**VILLAGE OF GERMANTOWN
N112 W17001 MEQUON ROAD
GERMANTOWN, WI 53022**

MEETING: REGULAR MEETING OF THE VILLAGE BOARD

DATE AND TIME: MONDAY, July 16, 2018 7:00 p.m.

Re : Harvest Hills Subdivision: Site Plan Review

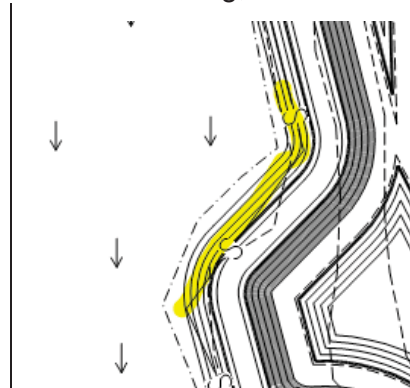
9. Adjust silt fence to be outside of proposed grading.

10. Show erosion control measures for the roadside swales. Matting, ditch checks, etc.

11. Show erosion matting on all slopes of 4:1 or steeper.

EC-3 Erosion Control Plan

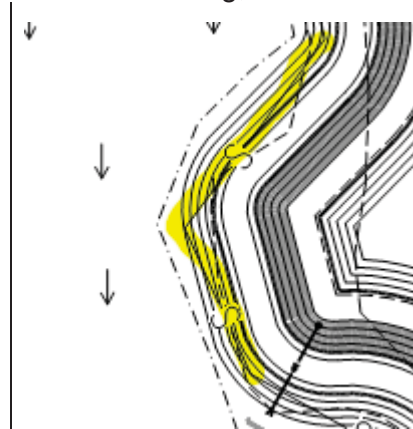
1. Show erosion control measures for the roadside swales. Matting, ditch checks, etc.
2. Adjust silt fence to be outside of proposed grading.

3. Add silt fence to contain runoff from all portions of the site.
4. Show erosion matting on all slope 4:1 and steeper.
5. Label erosion matting types.

EC-4 Erosion Control Plan

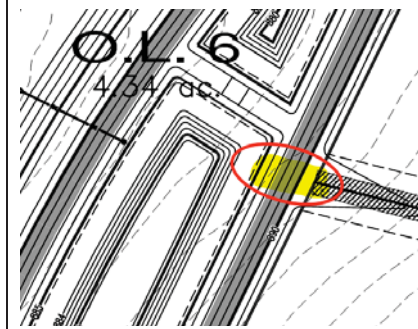
1. Show erosion control measures for construction of the driveway.

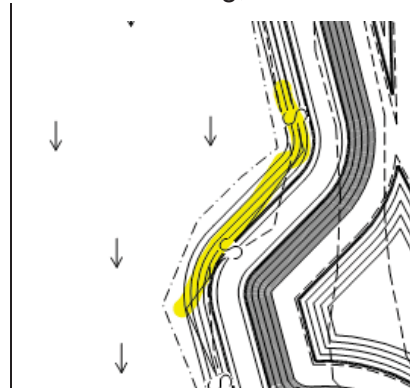
9. Adjust silt fence to be outside of proposed grading.

10. Show erosion control measures for the roadside swales. Matting, ditch checks, etc.

11. Show erosion matting on all slopes of 4:1 or steeper.

EC-3 Erosion Control Plan

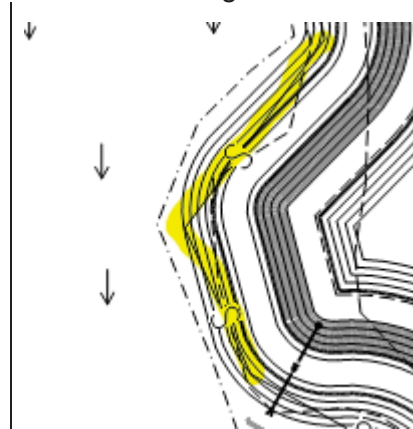
1. Show erosion control measures for the roadside swales. Matting, ditch checks, etc.
2. Adjust silt fence to be outside of proposed grading.

3. Add silt fence to contain runoff from all portions of the site.
4. Show erosion matting on all slope 4:1 and steeper.
5. Label erosion matting types.

EC-4 Erosion Control Plan

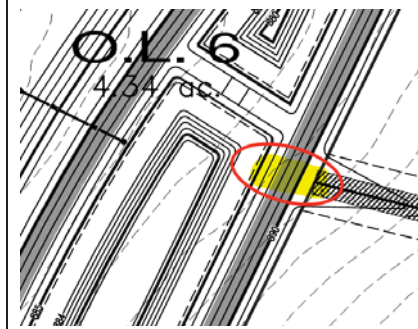
1. Show erosion control measures for construction of the driveway.

GP1

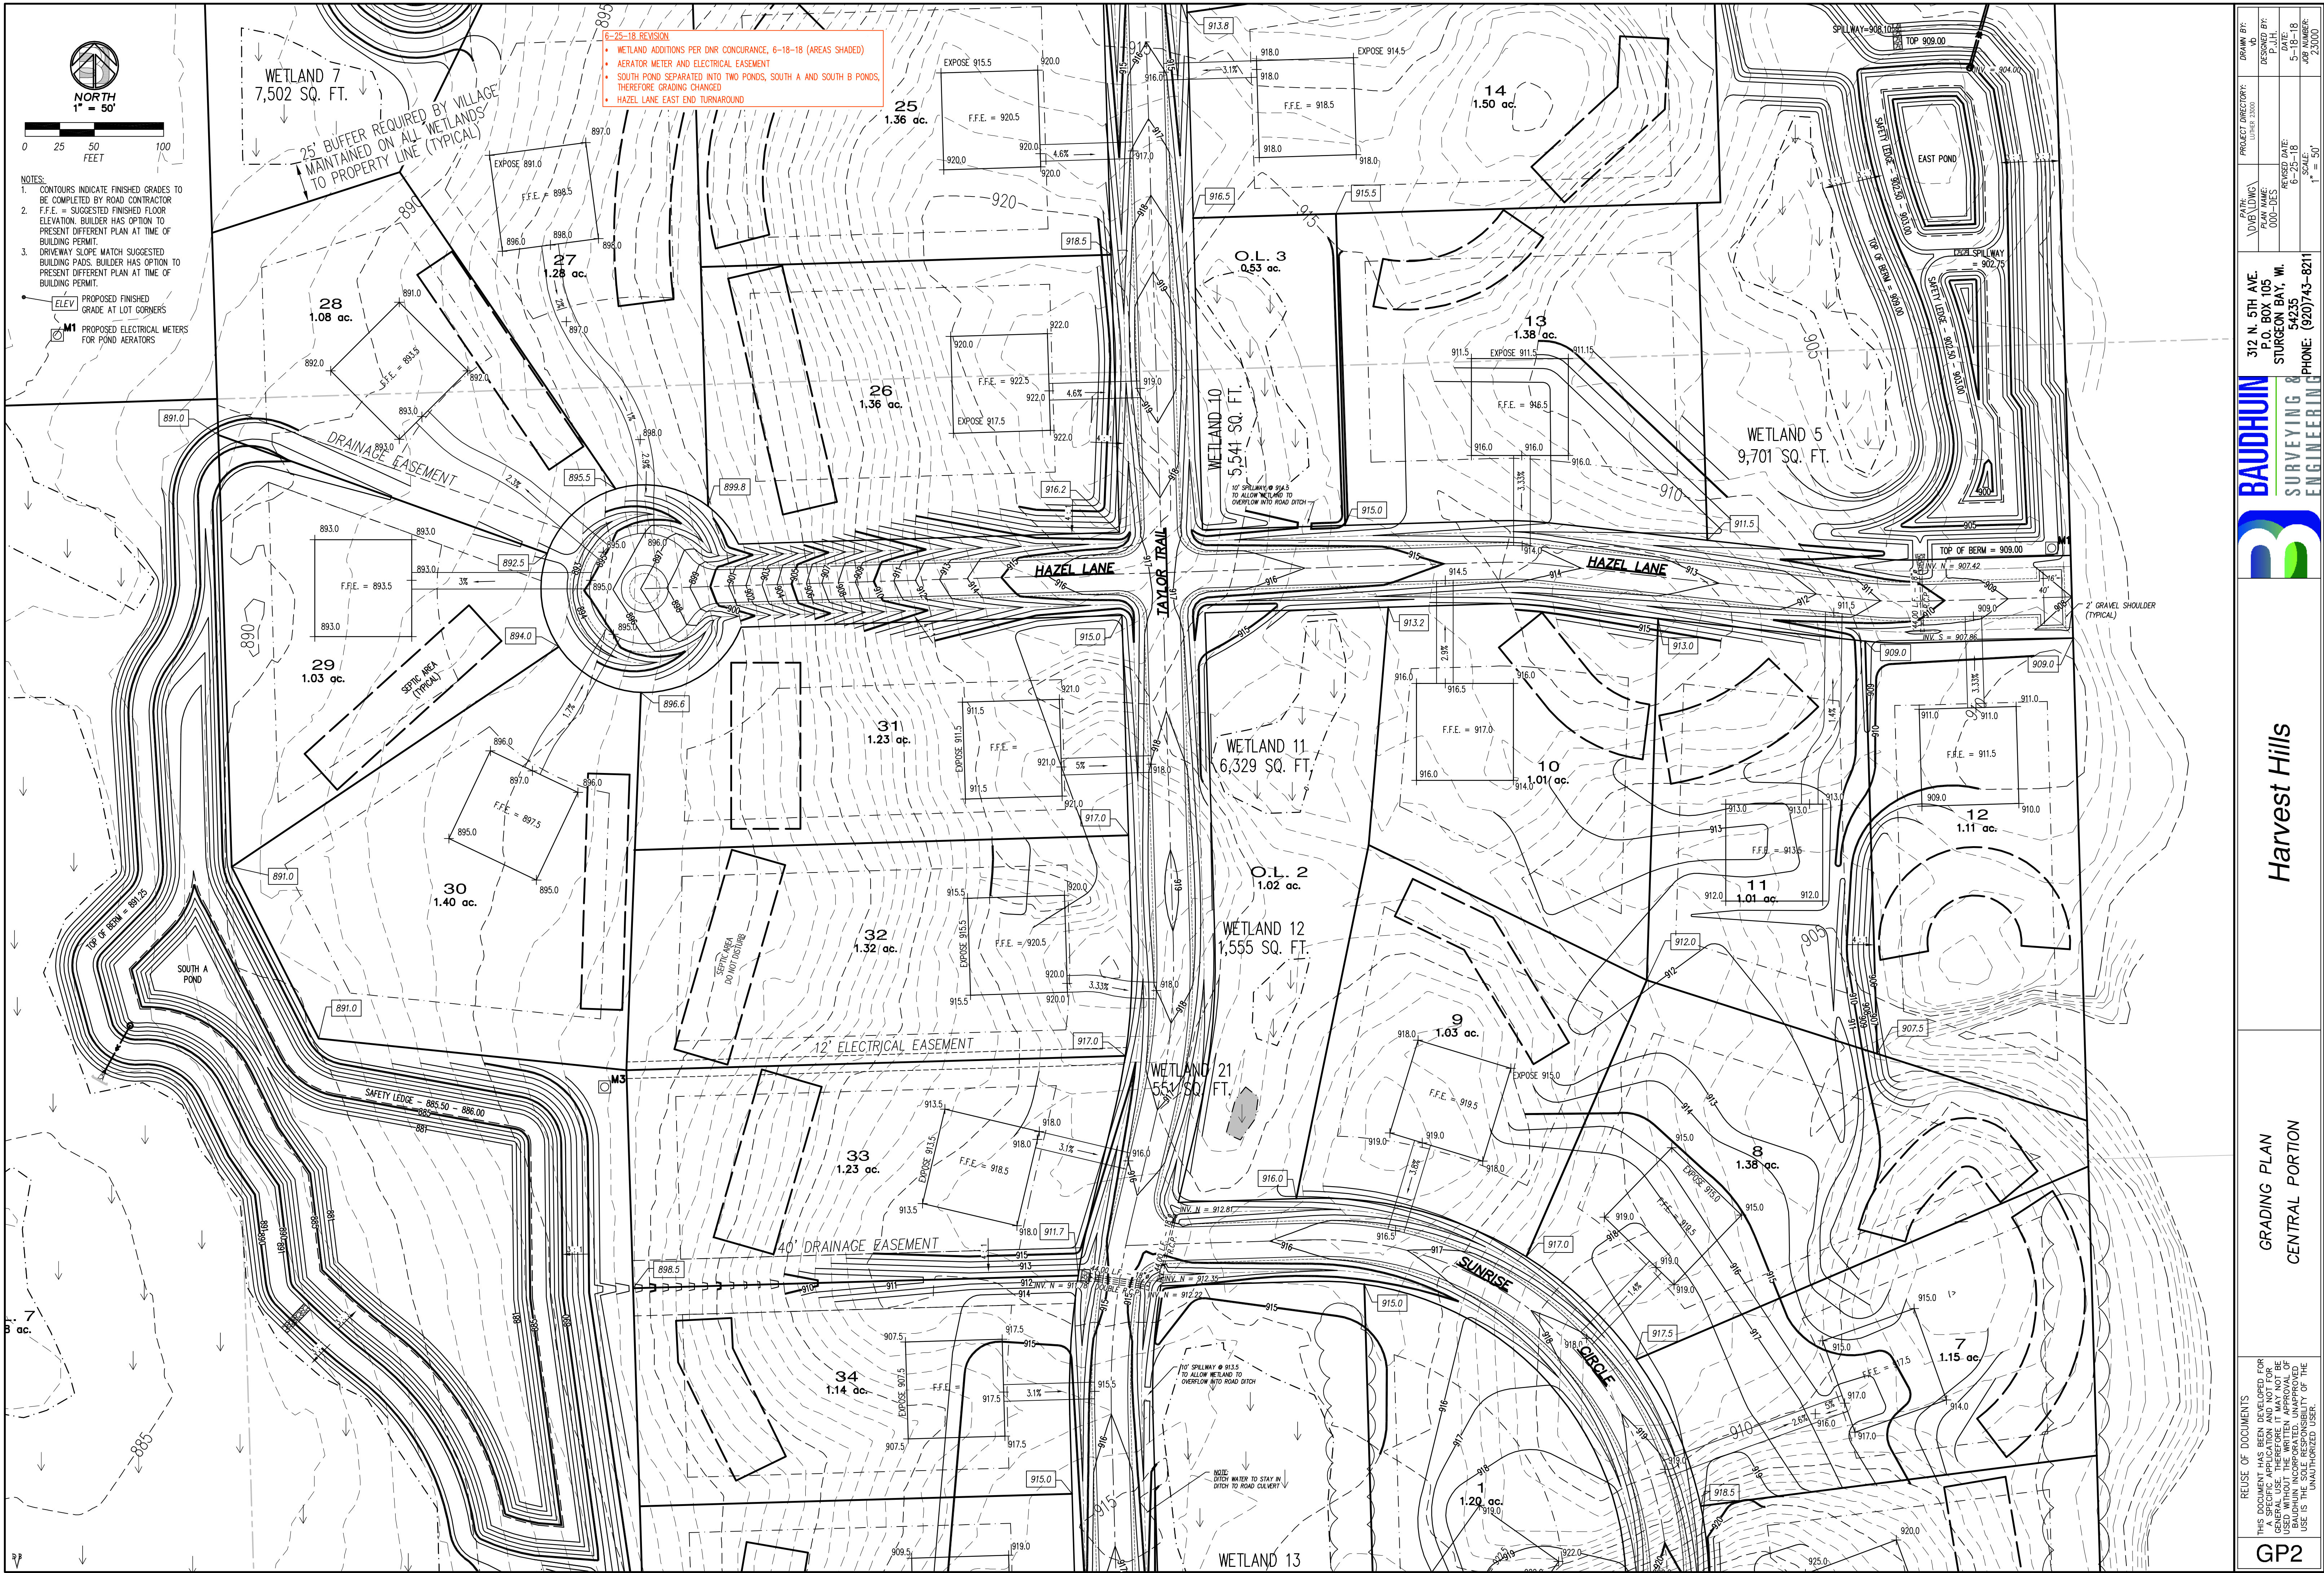
GP-1 Grading Plan

1. *Swale between lots 19 and 20 is very narrow and will be difficult to construct. Revise to widen the swale with a trapezoidal shape.*
2. *Lots 15 and 20 appear to have the septic area blocking access to the site. Demonstrate how driveway access will work for these sites.*
3. *Storm sewer at the rear of lot 22. Adjust to be a minimum of 10' from the property line to allow room for an easement.*
4. *Adjust limits of plan to show connection to CTH F.*
5. Culvert at lot 17 has less than 2' of cover. Adjust to provide a minimum of 2' of cover.
6. Culvert between lot 23 and 24 has less than 2' of cover. Adjust to provide a minimum of 2' of cover.
